North Country Environmental Services, Inc.

**RE: North Country Environmental Services, Inc.  
Landfill Facility – Bethlehem, New Hampshire  
Response to September 10, 2008 NHDES Comment letter**

**RE: Liner Leakage Analysis  
North Country Environmental Services  
Bethlehem, New Hampshire  
CMA #656.03 – A**

Figure 1 - Liner System Schematic

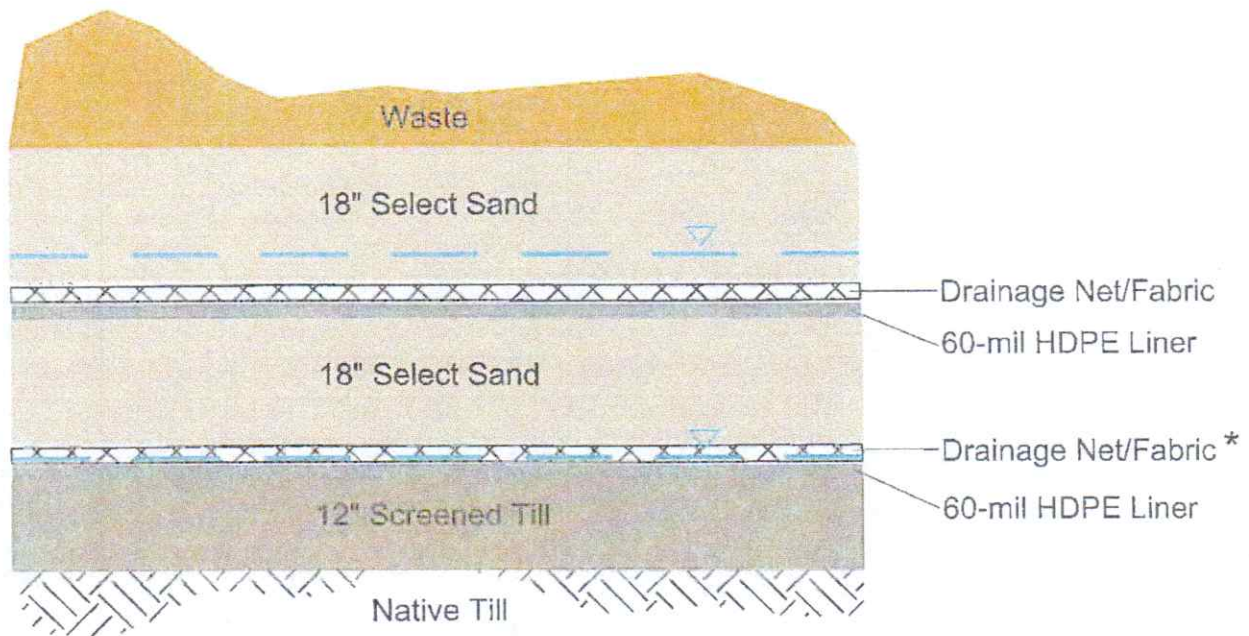
A typical lining system schematic for the NCES landfill is provided on Figure 1. The primary liner and leachate collection system consists of 18 inches of drainage sand, underlain by a drainage geocomposite (newer phases) or a drainage net and fabric (older phases), which in turn is underlain by a 60-mil high density polyethylene geomembrane liner. The secondary collection system is essentially a duplicate of the primary system with the same components and drainage capacity except for the flat, base areas of Stage I Phase II and III which do not incorporate drainage net/composite in the secondary collection system.

Figure 3 - Secondary Leachate Collection Systems

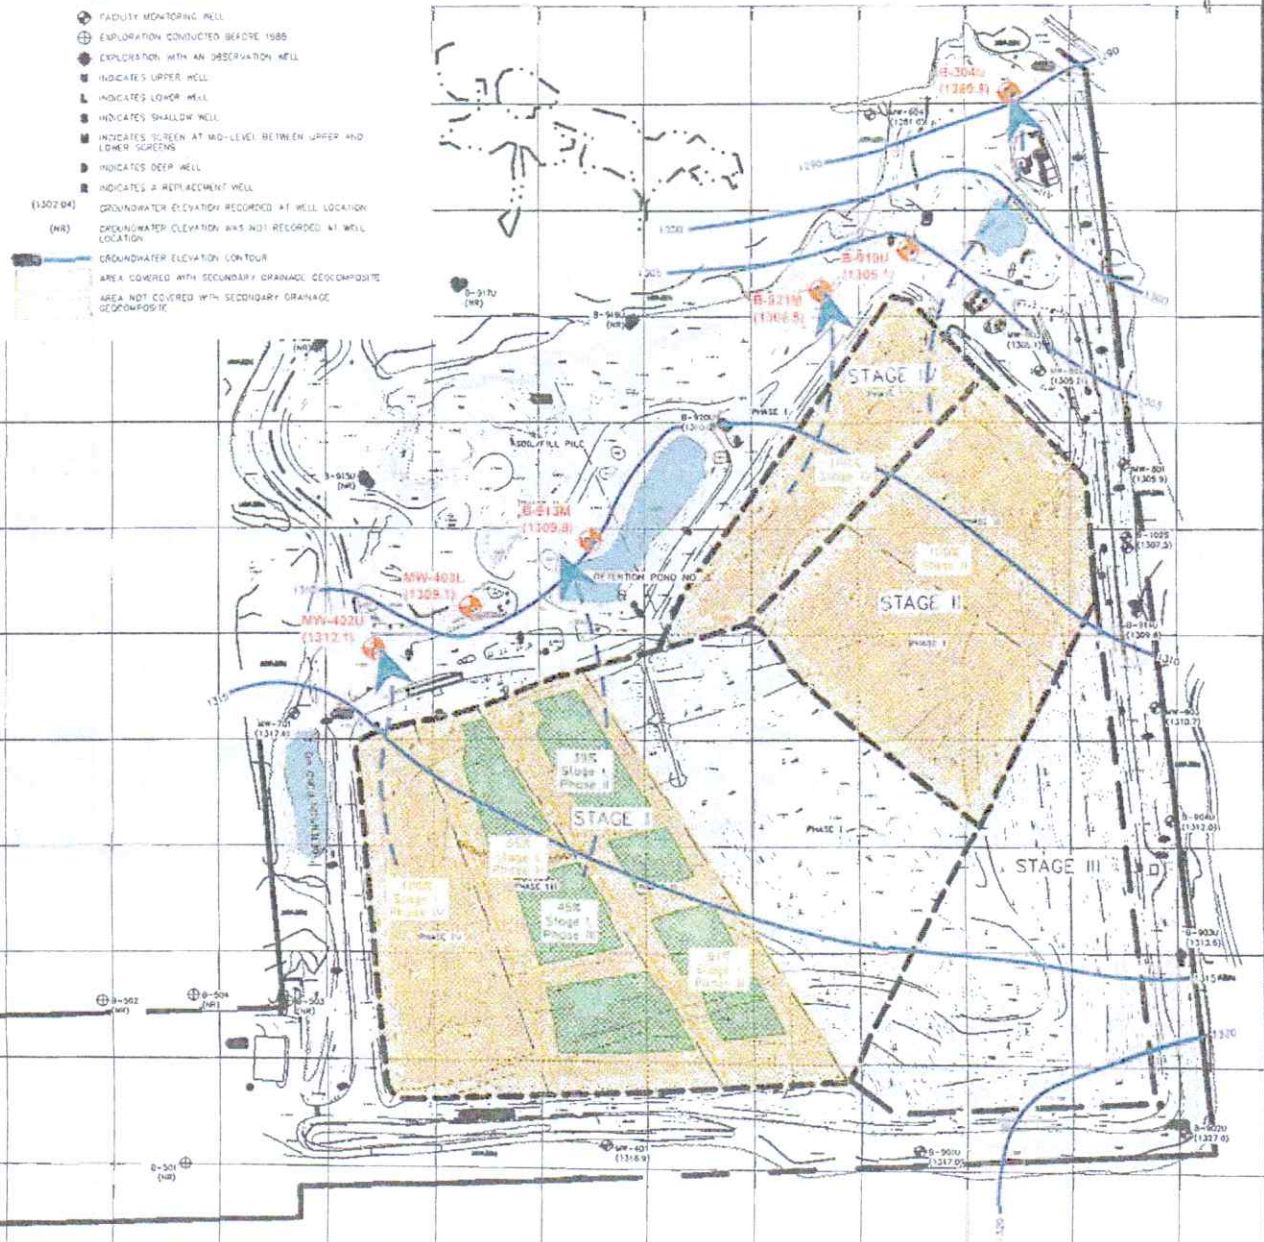
- Calculate the average head on the secondary liner using actual secondary flow data and the procedure described above for the primary liner, and account for the lack of drainage net on the flat base areas of Stage I Phases II and III. In these areas secondary flow is drained by drainage sand alone. The drainage sand is not as transmissive as the drainage net, resulting in higher heads on the liner than in areas with the drainage net. The landfill areas without drainage net are shown on Figure 3.
